Project	IEEE 802.16 Broadband Wireless Access Working Group < http://ieee802.org/16 >	
Title	Network Entry Through an RS with Distributed Security	
Date Submitted	2007-09-09	
Source(s)	Hang Zhang, Peiyong Zhu, Mo-Han Fong, Wen Tong, David Steer, Gamini Senarath, G.Q. Wang, Derek Yu, Israfil Bahceci, Robert Sun and Mark Naden Nortel 3500 Carling Avenue Ottawa, Ontario K2H 8E9	Voice: +613-763-1315 E-mail: wentong@nortel.com Voice: +613-765-8983 E-mail: pyzhu@nortel.com
Re:	IEEE P802.16j/D1: IEEE 802.16j working group letter ballot #28	
Abstract	For the distributed security case, the security materials of a MS attached to an access with distributed security are accessible and kept by the access RS. Such an RS can locally process MS's messages. This contribution clarifies the description about the MS initial network entry via an access RS with distributed security	
Purpose	To incorporate the proposed text into the P802.16j/D1 Baseline Document

Network Entry through an RS with Distributed Security

Figure 1. An example of MS initial network entry through an RS in moving BS mode.

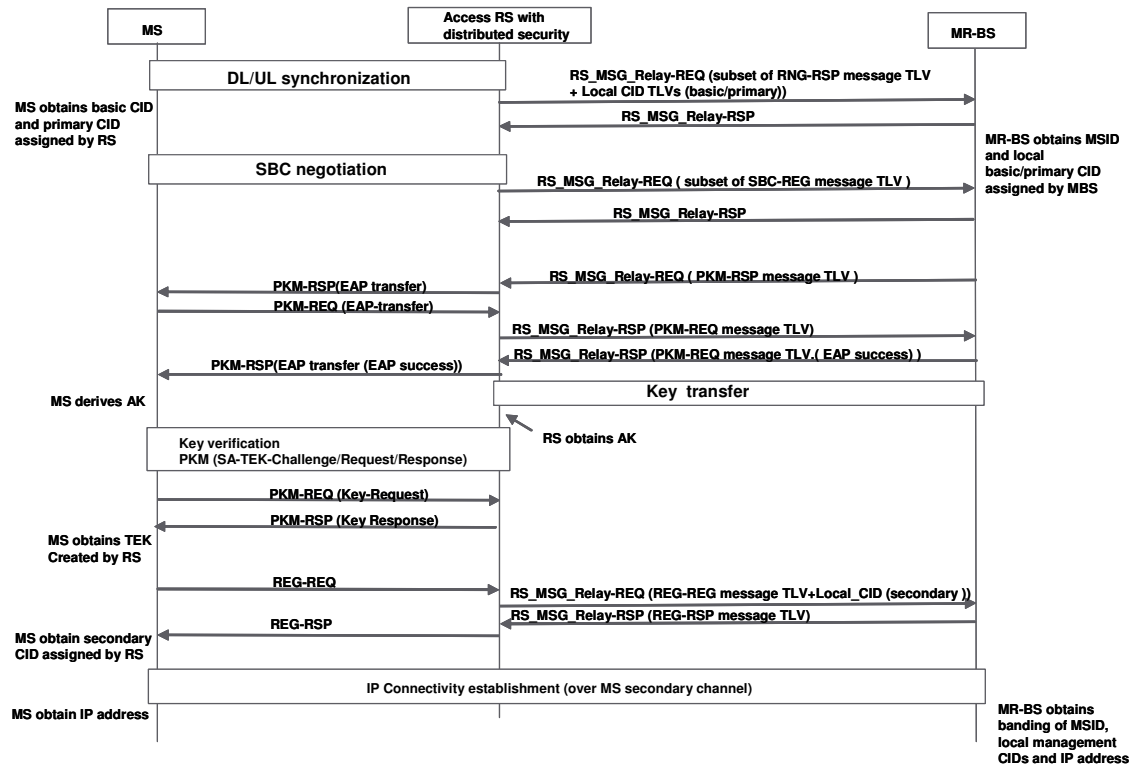
For MS initial network entry, some messages such as RNG-REQ/RSP and SBC-REQ/RSP can be locally processed first then the attachment of a MS is informed to the MR-BS. The information carried in messages such as PKM-REQ/RSP and REG-REQ/RSP need to be forwarded to MR-BS and the corresponding response of MR-BS needs to be forwarded to MS. The MS initial network entry through an RS with distributed security is illustrated in Figure 1.

- DL/UL synchronization
 - For DL synchronization, no any additional requirement for an access RS
 - During MS UL synchronization, the RS shall locally assign a basic CID and a primary CID to the MS

- After the MS DL/UL synchronization, the RS may send RS_MSG_Relay-REQ message to MR-BS which include the TLVs of RNG-REQ/RSP (those TLVs may be transmitted to MR-BS after SBC-REQ/RSP exchange)

- SS MAC Address
 - Basic CID and primary CID (locally assigned to the MS)
 - The MR-BS shall response with RS_MSG_Relay-RSP message
 - No TLV of RNG-RSP TLV is included

- After the MS DL/UL synchronization, the MR-BS establishes a binding between the MS ID and the basic CID and primary CID locally assigned by the RS
- Basic capability negotiation

- A MS and an access RS negotiate the basic capability locally through SCB-REQ/RSP messages without involvement of MR-BS
 - After the negotiation between the MS and the RS, the RS shall send RS_MSG_Relay-REQ message to MR-BS. The following TLVs of SBC-REQ message may be included

- Security Negotiation Parameters
 - MR-BS shall send RS_MSG_Relay response message to the access RS as a response to RS_MSG_Relay-REQ sent from the access RS

- No TLV of SBC-REQ/RSP TLV is included
 - The RS_MSG_Relay-RSP message may includes the TLVs of RNG-REQ/RSP messages if the access RS decides to combine those information together
